|  | Department of Design and Construction | SPECIFICATION BULLETIN | SB 25-002 |
| Title: WATER MAIN LOCK-OUT / TAG-OUT | | | |

REVISIONS TO THE NEW YORK CITY DEPARTMENT OF ENVIRONMENTAL PROTECTION STANDARD SEWER AND WATER SPECIFICATIONS, DATED 8/8/2022:

SECTION 40.14 – WATER MAIN LOCK-OUT / TAG-OUT (LOTO)

VALVE CAN SKETCH

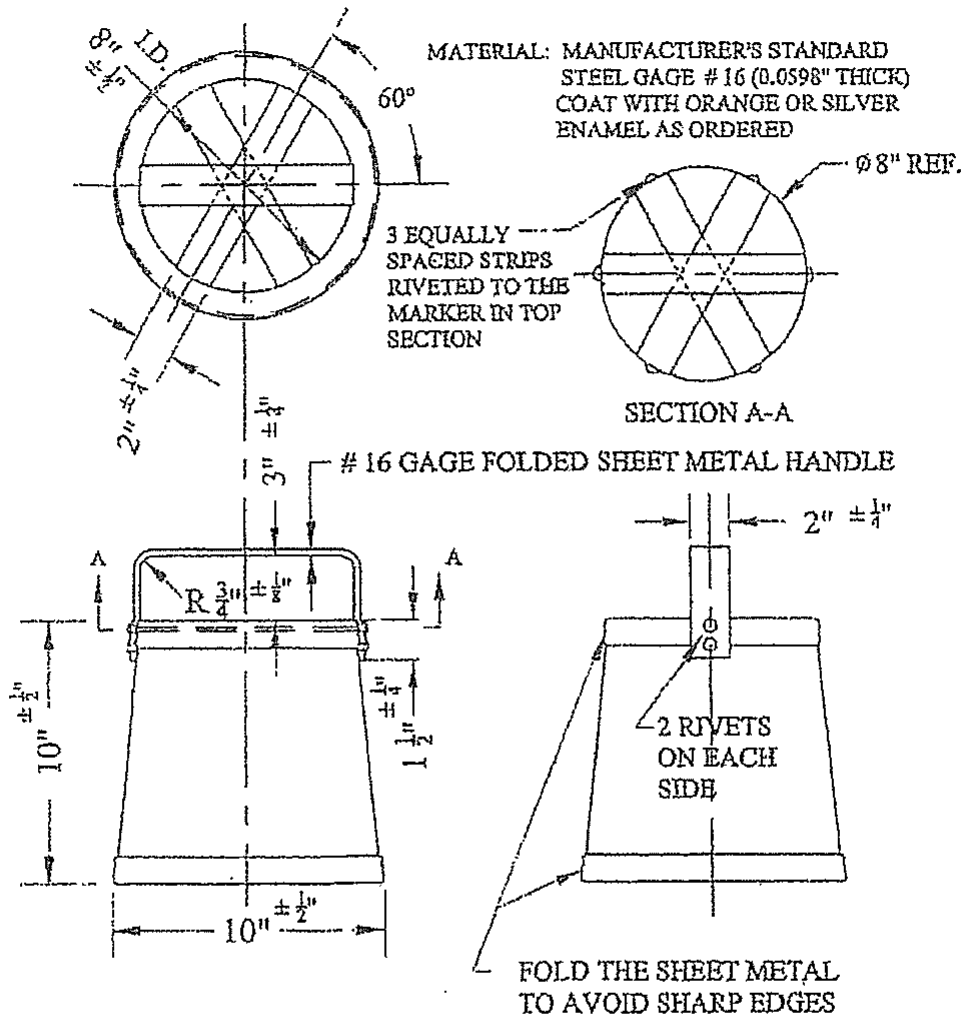
- (A) Valve Cans: Valve cans must be sheet metal covers, meeting the requirements of sketch M-161 at the end of this **Section**.
- (B) Locks: Locks must be of a type intended for LOTO. Locks must be padlock type and have blue plastic bodies.
